Date: October 2020

Dimension Tolerances Change of SLEC-B-EL: Clamping Screws with Eccentric Heads

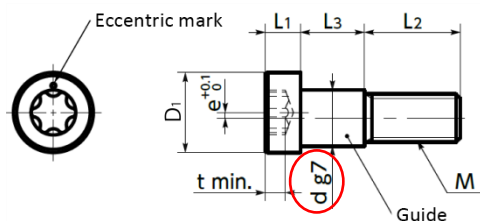
We hope you are doing well and appreciate your constant business support of NBK. The guide portion (“d” in the following dimension drawing) and mount fit tolerance for clamping screws with eccentric heads “SLEC-B-EL (guide type, electroless nickel plating)” listed in the [NBK Catalog 2017] will be changed as follows.

The fit tolerances between the guide and mount will be changed due to manufacturing reasons.

●Guide diameter (d) tolerance for SLEC-B-EL

Before Change	After Change
SLEC-M3-B-EL SLEC-M4-B-EL SLEC-M5-B-EL	g7	+0.008 -0.016
SLEC-M6-B-EL SLEC-M8-B-EL		+0.007 -0.020

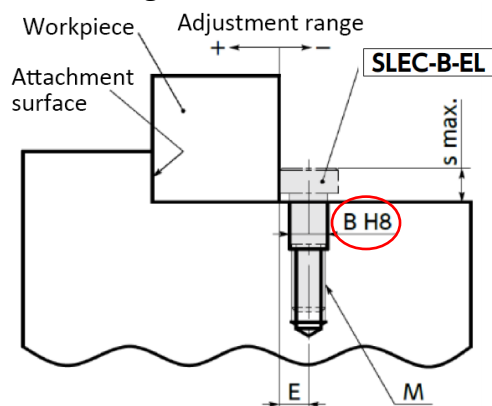
● Mounting bore diameter (B) tolerance

Before Change	After Change
SLEC-B-EL All Sizes	H8	F8
